THE BRITISH MUSEUM

East Road Building

Planning Addendum Summary

REV A

Revised Basement - Level 01

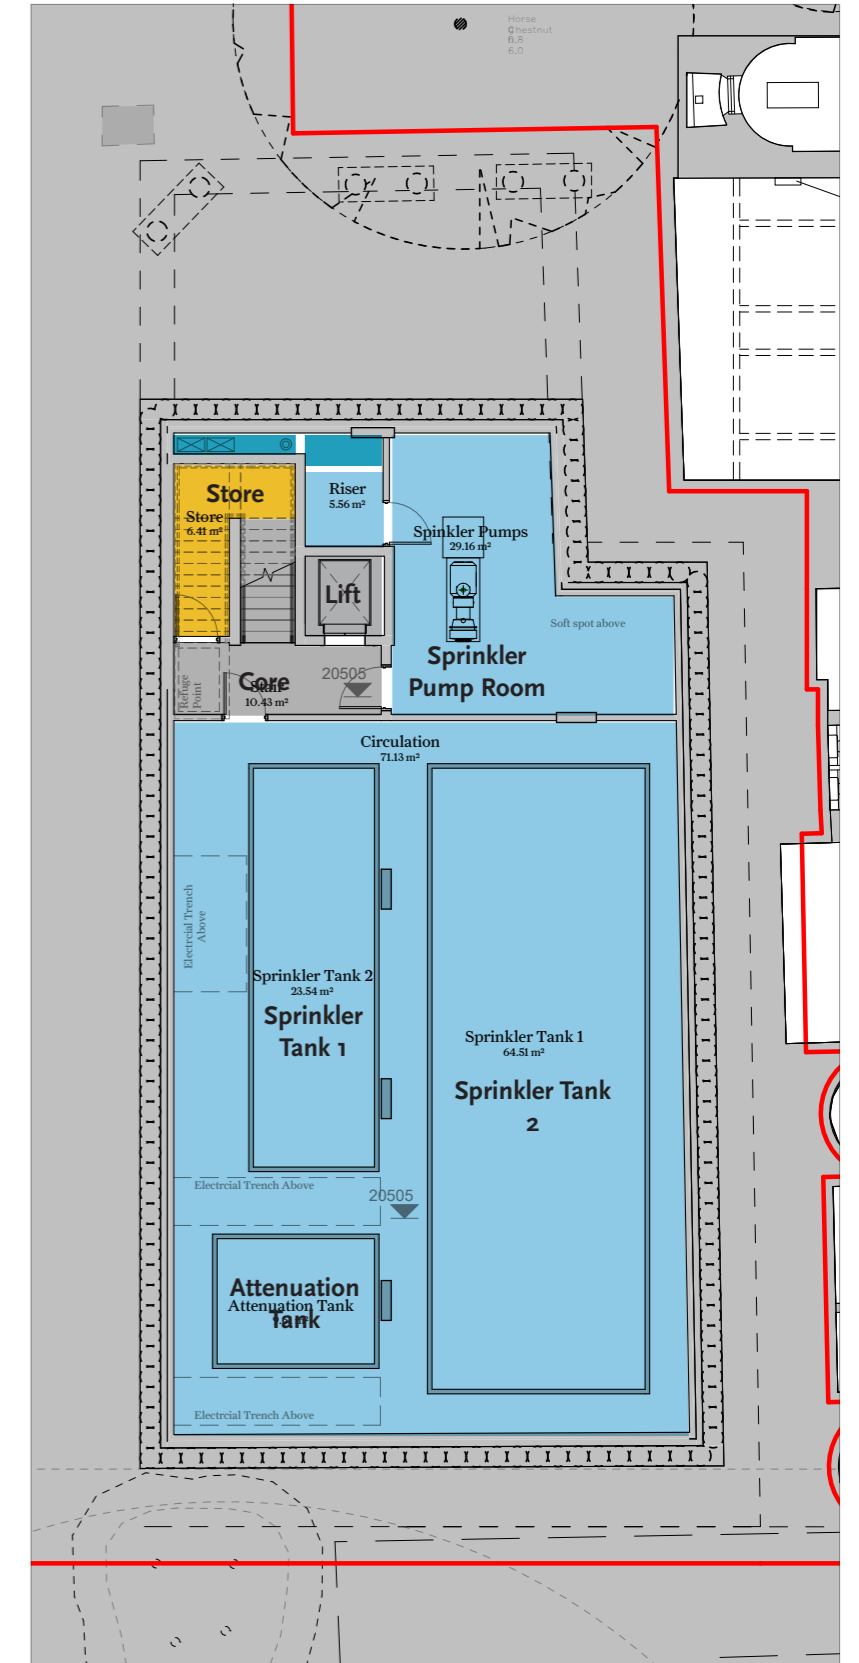
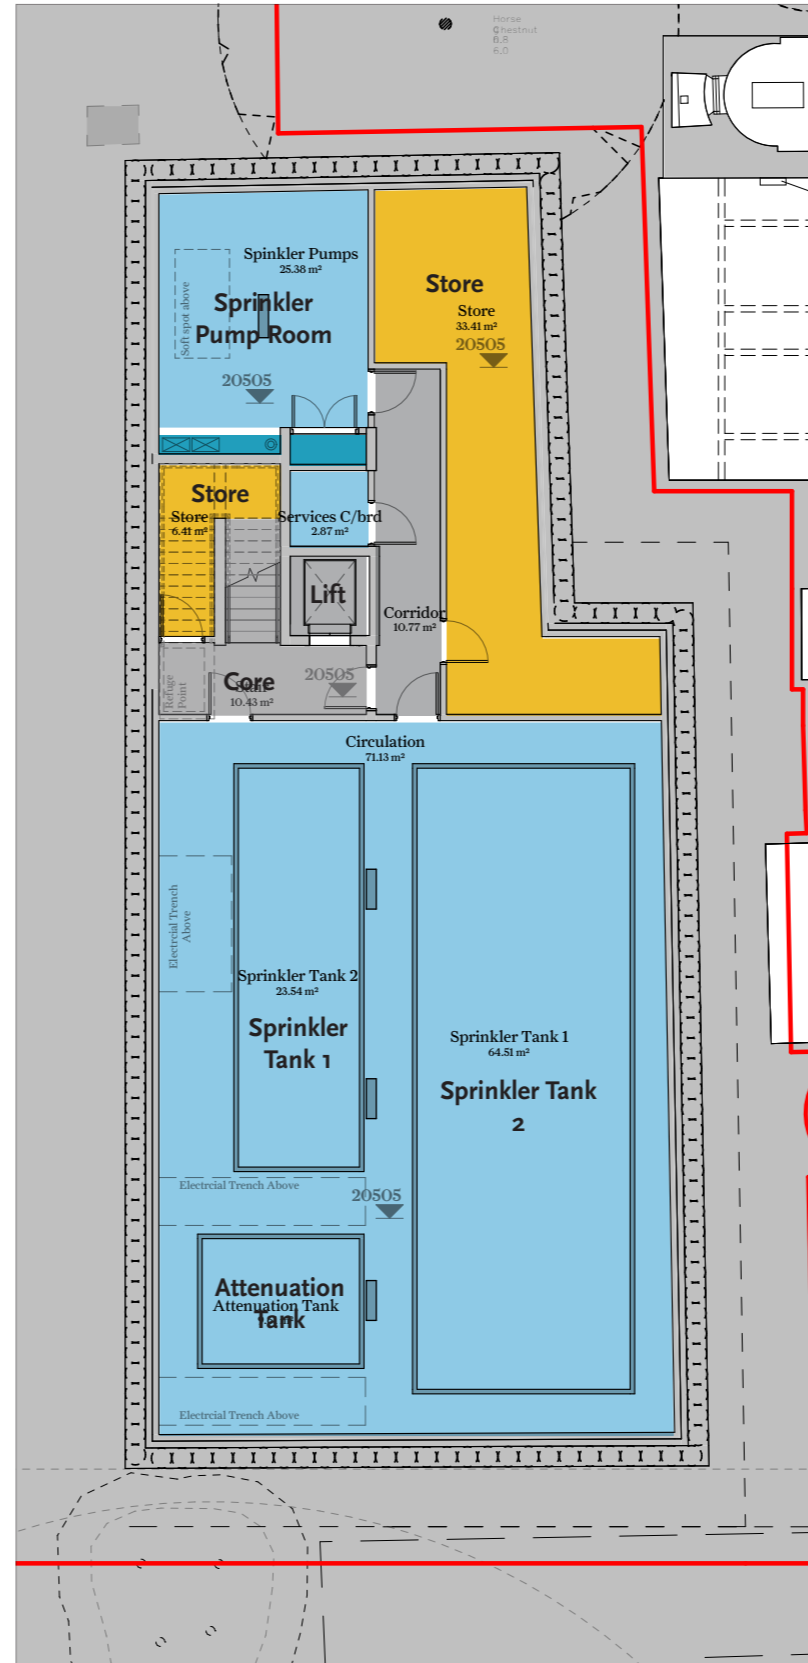
A number of areas were reviewed and the decision was taken to omit the storage area in the northern end of the proposed basement in order to reduce the overall basement footprint. The drawings adjacent illustrate the revised basement footprint on the right, in comparison to the submitted proposal on the left. The following page shows an equivalent comparison of a long section through the proposed building.

For the avoidance of doubt, this change has had **no** impact on the overall above ground bulk scale and massing, nor the elevations as submitted in the Design and Access Statement 11.04.2023 (Rev C).
